Developer Services
Southern Water
Sparrowgrove House
Sparrowgrove
Otterbourne
Hampshire
SO21 2SW

PLAN-019044

Proposal: 2 No. dwellings. This application is a Departure of the Development Plan.
Site: Land West of Fontwell Avenue, Eastergate, PO20 3RU.
AL/72/17/PL

SOUTHERN WATER

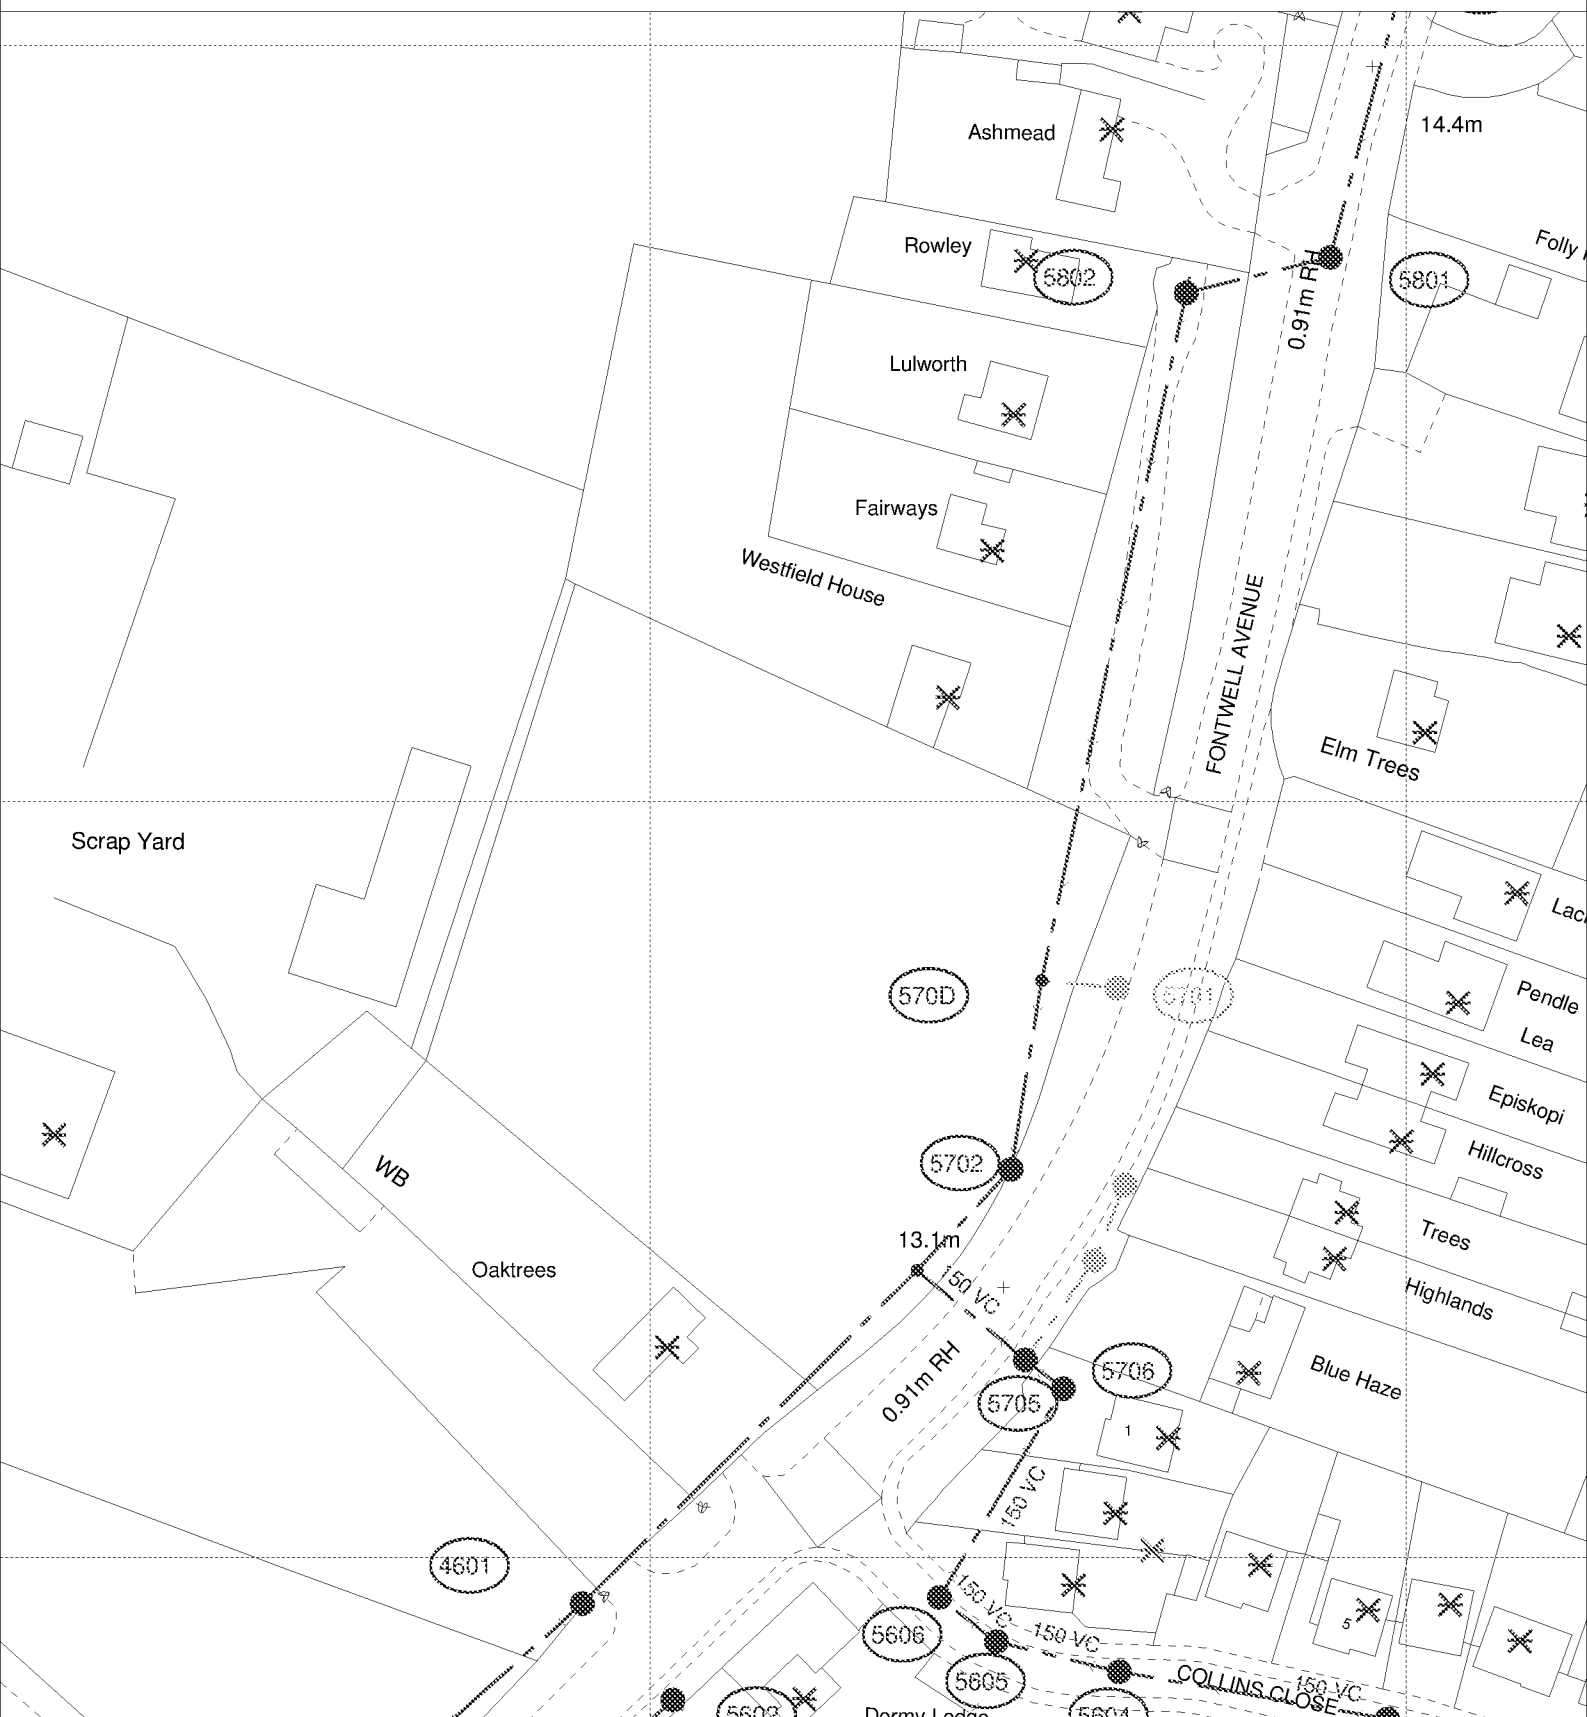
Please find attached a plan of the sewer records showing the approximate position of foul sewer in the access to the site. The exact position of the foul sewers must be determined on site by the applicant before the layout of the proposed development is finalised.

- No development or new tree planting should be located within 3 metres either side of the centreline of the foul sewer.
- No new soakaways should be located within 5m of a public sewer.
- All existing infrastructure should be protected during the course of construction works.
